Applicant : Bruce C. Bacon
Serial No. : 10/806,264
Confirmation : 1927
Atty. Dkt. : BAU03 P-308
Page : 19

Remarks/Arguments:

Amendments to the Drawings:

Fig. 18

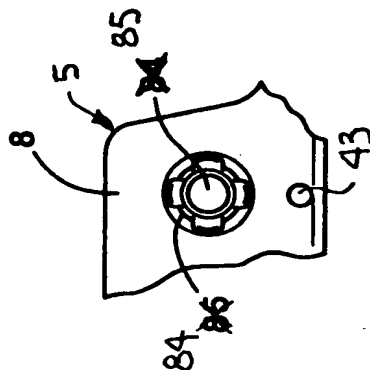
In response to the Examiner's objection to the drawings, Fig. 18 has been amended to change original reference numeral "84" to --85--, and original reference numeral "85" to --84--. One sheet of proposed amended drawings is submitted herewith in which the corrections are noted. Also enclosed are three sheets of formal drawings, as corrected. The Examiner's approval of the proposed drawing corrections is solicited.

The drawings have been amended to correct Fig. 18 by changing original reference numeral 84 to reference numeral 85 and original reference numeral 85 to reference numeral 84. The requested corrections are shown on the enclosed annotated sheet of drawings. Also enclosed are three sheets for formal drawings to replace the informal drawings filed with the application.
